Memorandum

Subject

One Medlock Street – AVO Assessment

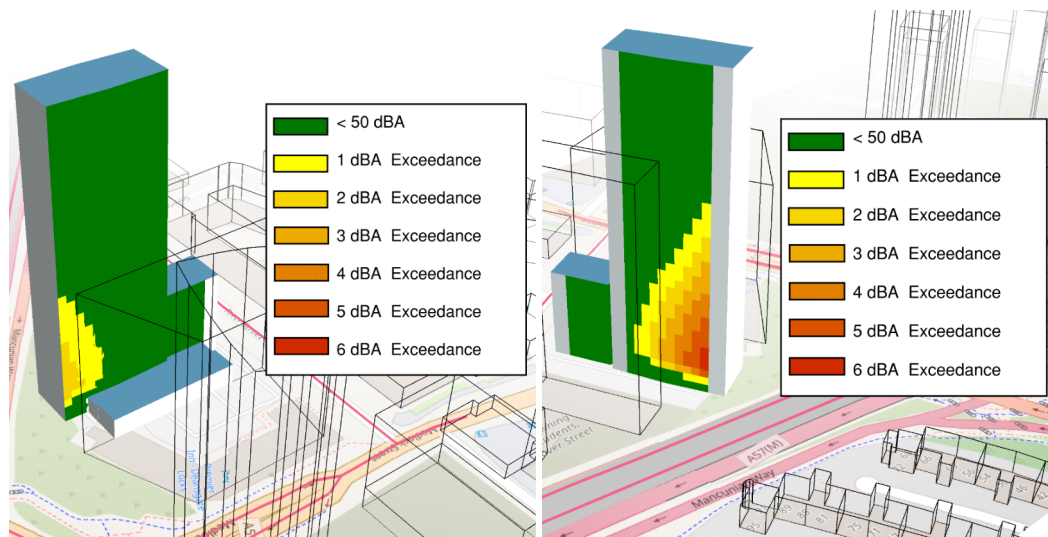
It has been stated in Chapter 8 of the Environmental Statement that the requirements of Approved Document O will be met with regards to overheating but we need to see a Level 2 Overheating Assessment in accordance with the AVO Guide (2020) to ensure that acoustics and overheating are both considered together. They have also stated that a detailed glazing attenuation will be undertaken and this should be done alongside the Level 2 Overheating Assessment.

Re the additional documents for overheating - Whilst we partly agree with the assessment, based on the windows being open for 5 hours in the quietest part of the evening (18:00 to 23:00) in line with ADO for Building Regulations, they have not included the resultant internal noise levels with the windows open or included an assessment of impact (as stated in AVO Guide which is applicable to daytime noise). They need to add this additional assessment to support the over heating assessment to ensure the occupiers are not being exposed to unacceptable noise levels with the windows open, the AVO guide includes tables and graphs to assess the impact (e.g. Tables 3-2 and 3-3 and figure 3-2). This will ensure that the overheating assessment balances acoustics and thermal comfort, as the current assessment has not taken the acoustic report into account.

Considering the above, and the illustration of the Cundall's interpretation of the daytime condition in the AVO diagram below, the predicted levels are below the "SOAEL" level, and below a level at which noise causes a material change in behaviour in Table 3-3 of the AVO Guide. They are therefore considered to be suitable for occupants given the very low overheating risk, and hence limited periods of time that windows are required to be open to mitigate overheating during the day (and with no requirement to open windows to mitigate cooling at night).
